Re: TPDES Major Amendment Application Harris County Municipal Utility District No. 171 Wastewater Treatment Plant TCEQ Permit No. WQ0015264001

TPDES Major Amendment Permit Application

Harris County Municipal Utility District No. 171 Wastewater Treatment Plant TCEQ Permit No. WQ0015264001

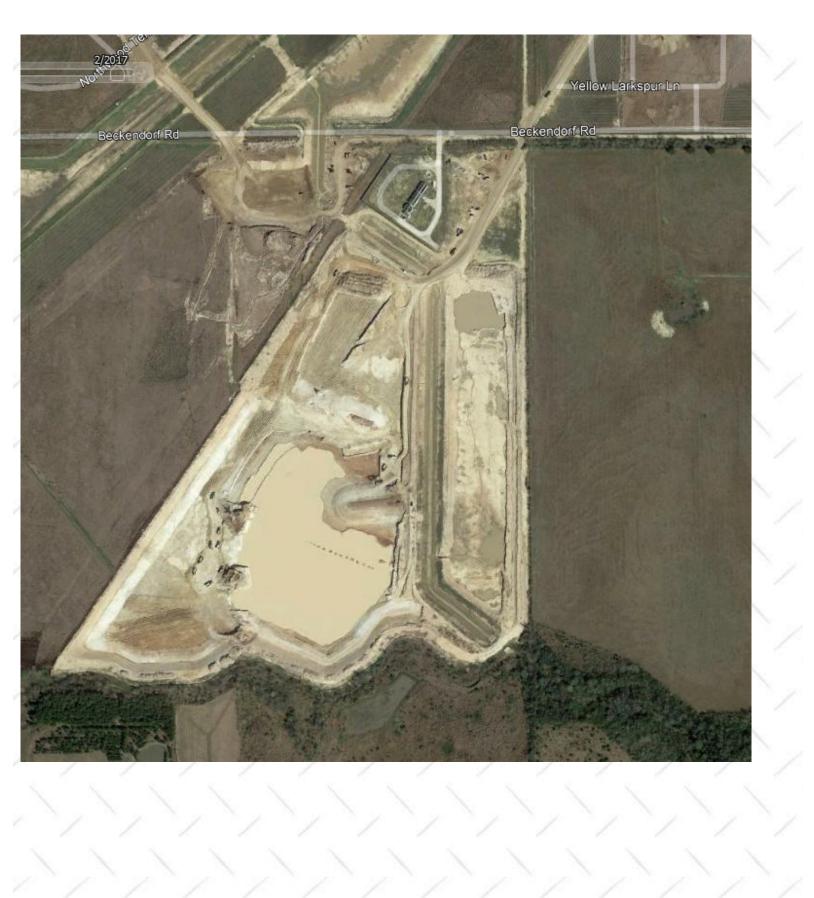
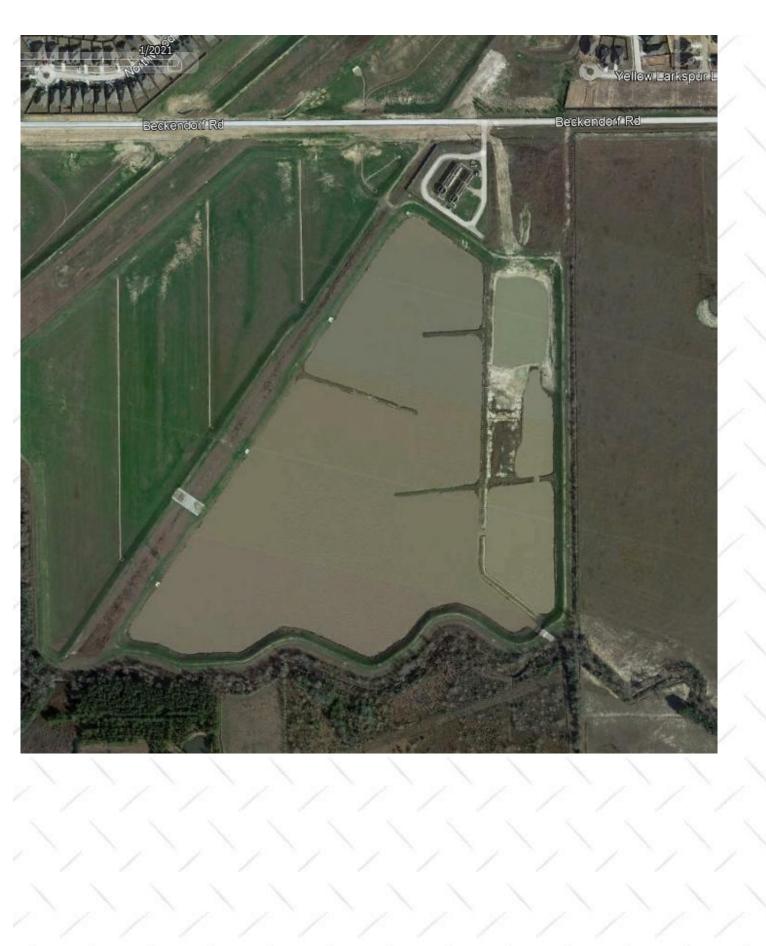
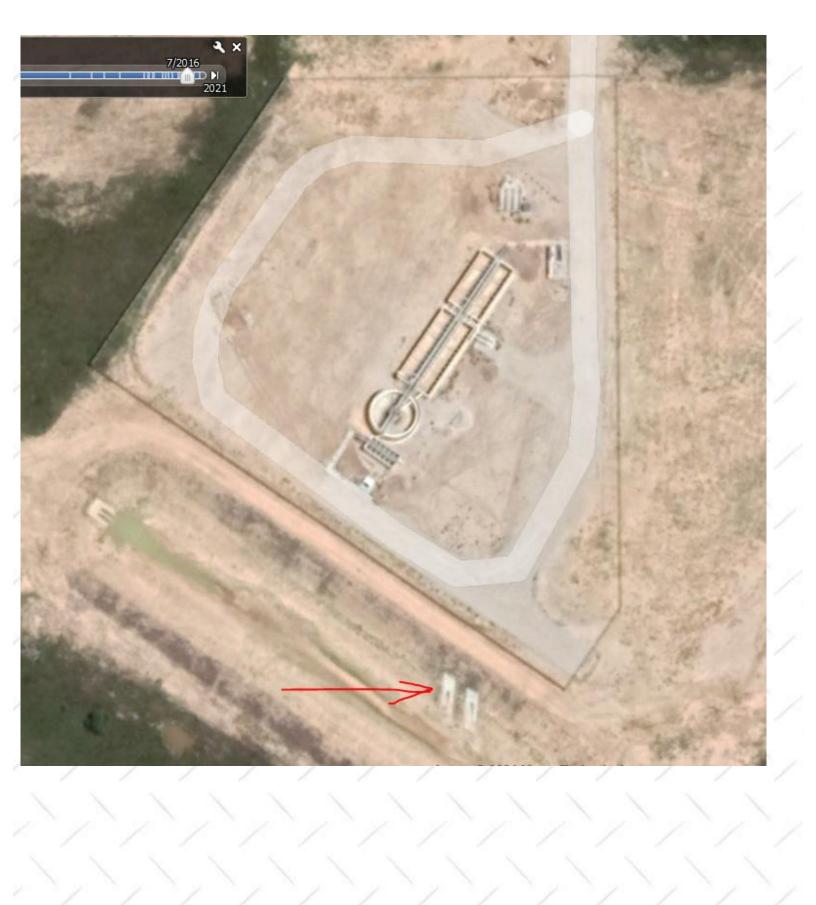
I am from the water quality assessment team and working on the subject permit. Do you have any size information about the detention pond (like average water depth).

Greetings – your interpretation is essentially correct: the "man-made ditch" was expanded into the detention basin. The detention basin still overflows to the same point as before expansion and the outfall has never been moved. See time-series satellite pictures below. Let me know if you need to discuss.
